Review comment responses for

A comprehensive data acquisition and management system for an ecosystem-scale peatland warming and elevated CO₂ experiment

Krassovski et al..

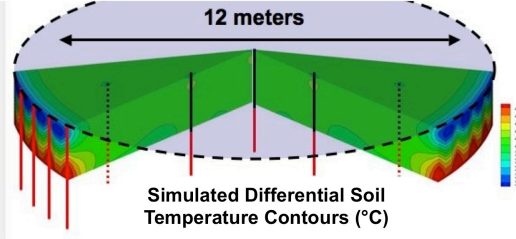
How are they related to / different from the 17 12m-plots mentioned in the first group? Also the different heating systems – one for soil heating from underneath the surface, the other for air heating above the surface – would be useful to highlight in the text. This information is currently only available from thorough studying of figure 2.

The edited text above should resolve these issues, and a revised Figure 2 will be added with up-to-date images of the final enclosures.
